U. S. ATOMIC ENERGY COMMISSION

REPORT TO ADVISORY COMMITTEE ON REACTOR SAFEGUARDS

INDIAN POINT NUCLEAR GENERATING STATION UNIT NO. 2

DOCKET NO. 50-247

FIG. 2-1

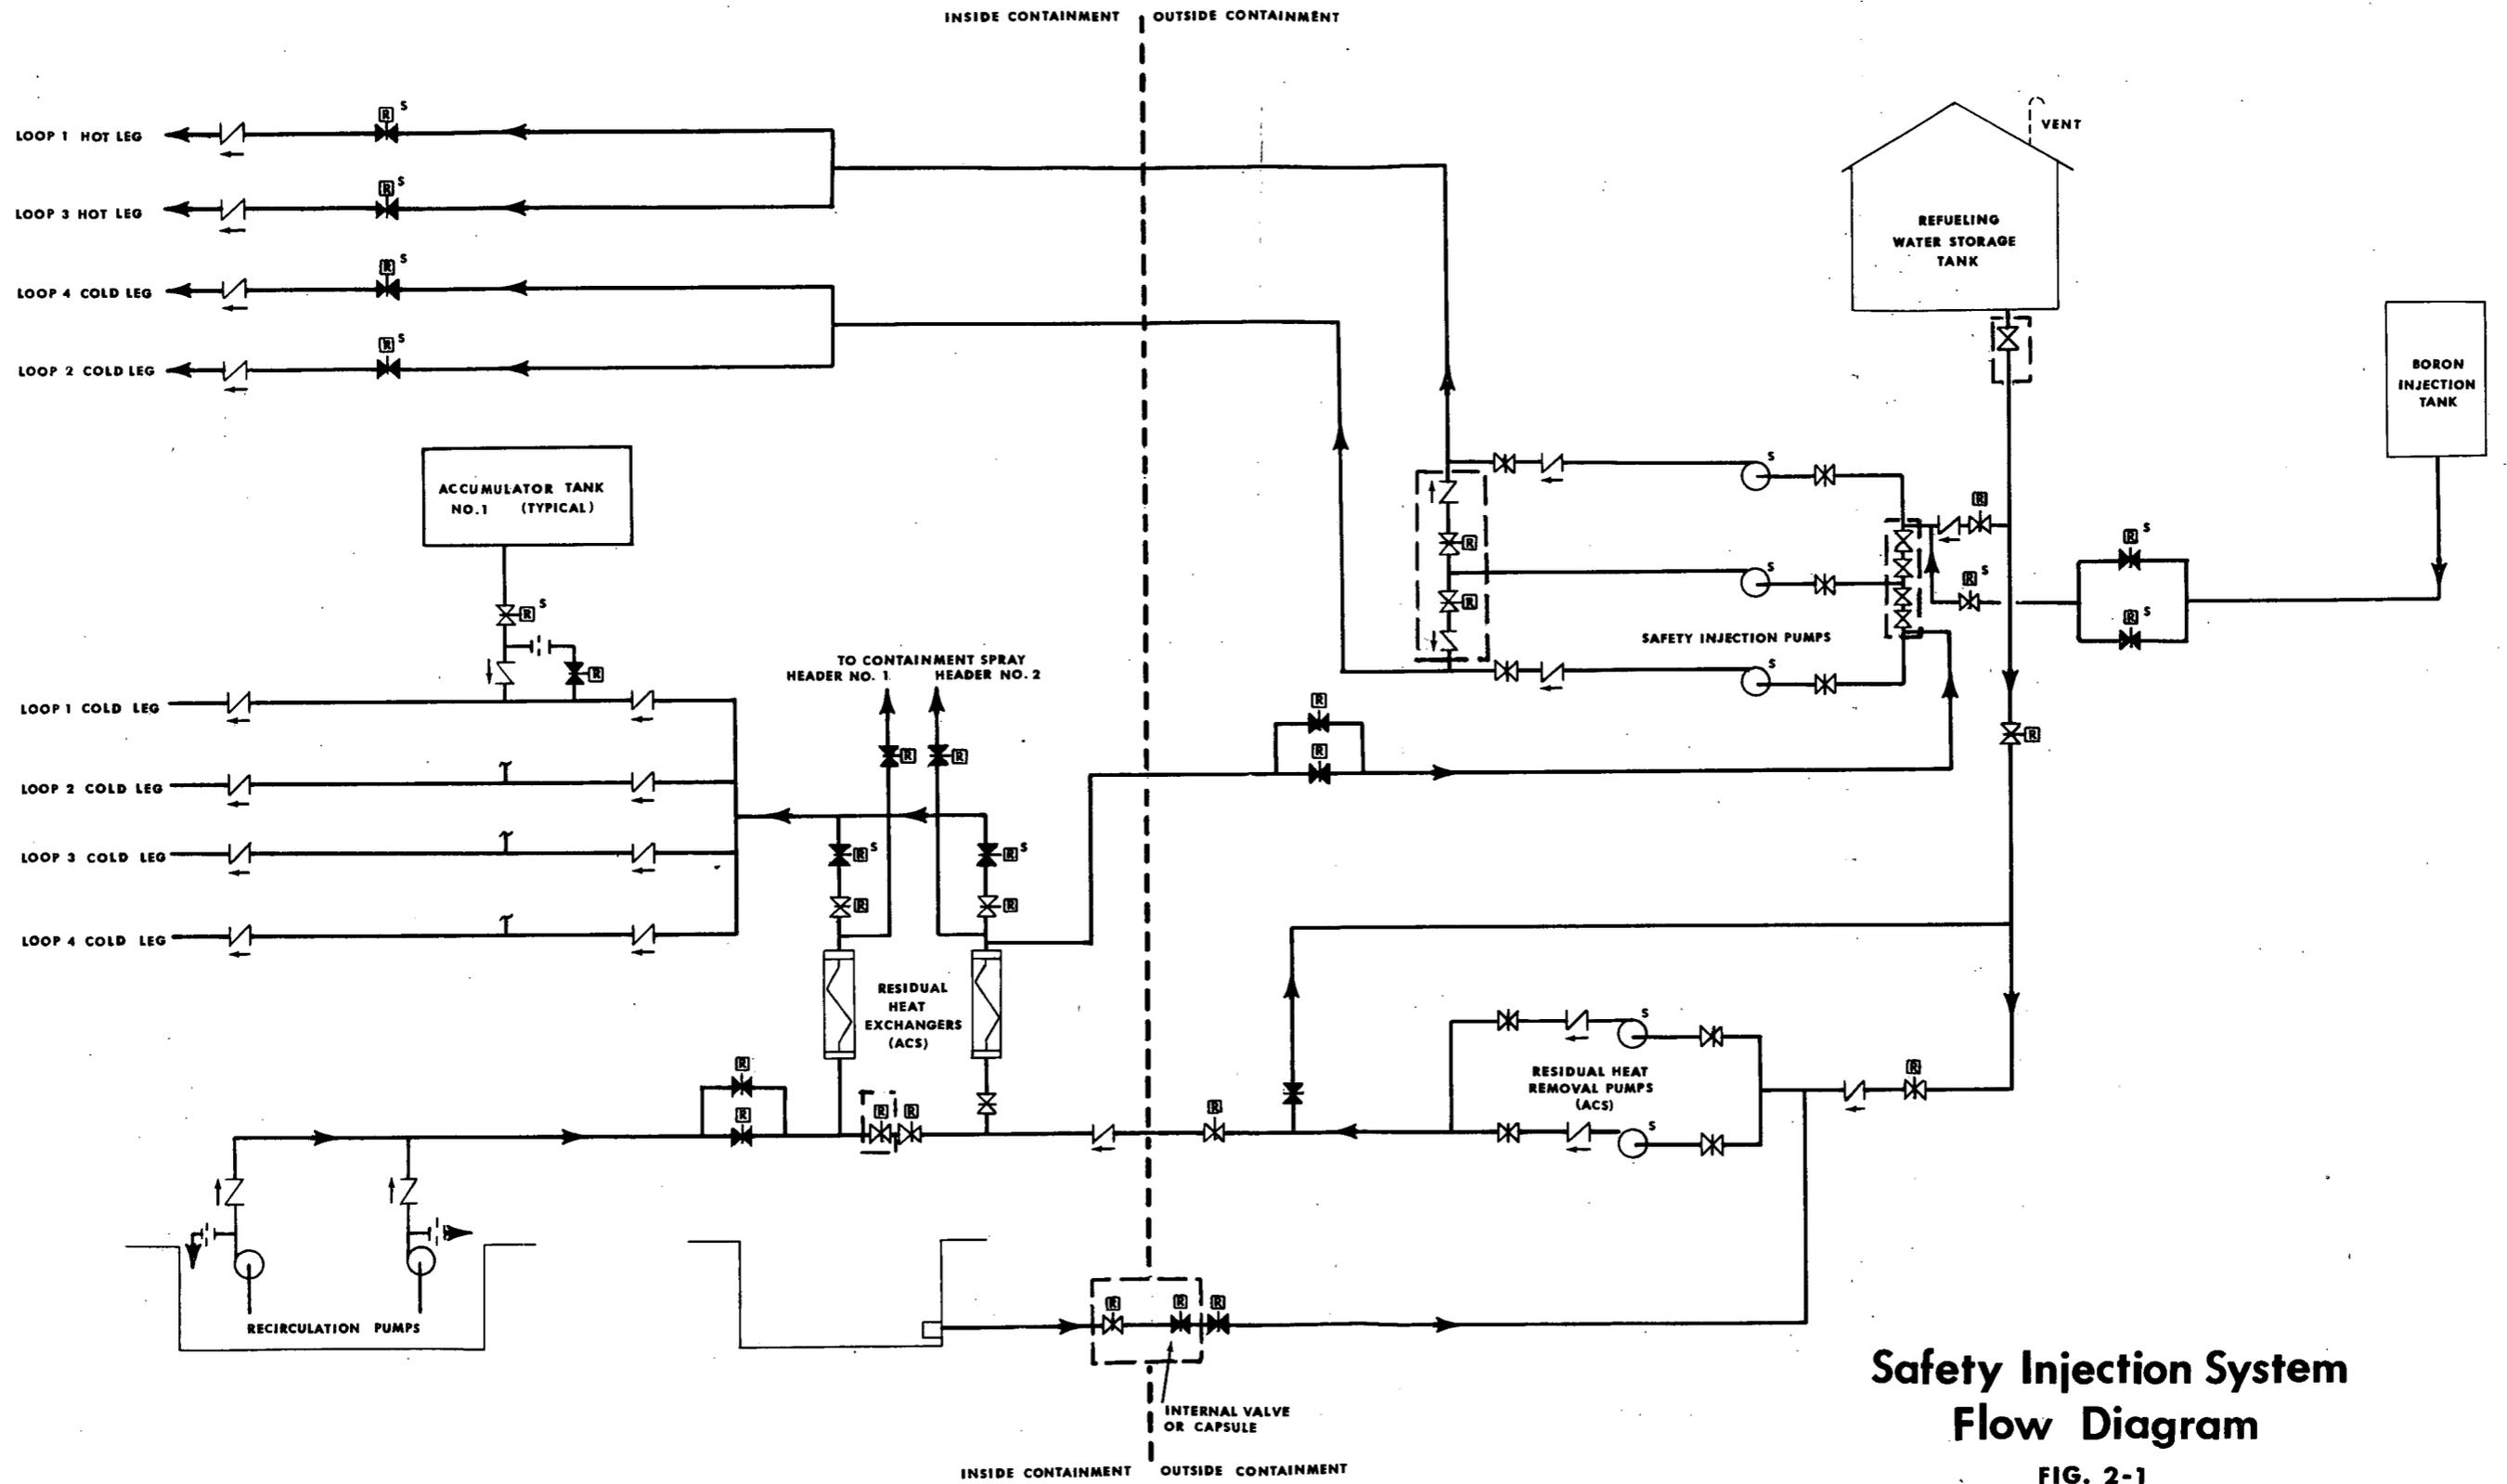
The ECCS as now proposed is shown in Figure 2-1. This figure is a simplified version of Figure 1-1 in the seventh supplement, and it shows the valves which have been added to accommodate passive failures in the long-term (low-head) subsystems and to provide leakage isolation capabilities. The additions or changes are enclosed in broken lines. The spectrum of break sizes for which various combinations of high-head safety injection, low-head safety injection, and accumulator injection are effective is given in Figure 2-2.

The high-pressure injection system consists of three pumps discharging to two separate headers. Two out of three pumps discharging through either a single or both headers will perform the required core cooling functions. The pump discharge header arrangement allows for active component failure without affecting the required performance. In addition, the valves added in the inlet header, the valve arrangement in the discharge header, and the valve added at the RWST outlet now allow this system to accommodate a passive failure in the long-term recirculation cooling mode. Although the arrangement is somewhat different than that proposed for the recent Westinghouse four-loop plants, we conclude that it meets the desired objective and is acceptable.

The applicant has recognized that it will be necessary to modify the design in the line between the containment sump and the residual heat removal

pump inlet header since a single failure of the valve adjacent to the containment could result in unacceptable leakage from the containment. He will install an isolation valve inside the containment or place the first external valve in a leak-tight capsule as shown in Figure 2-1.
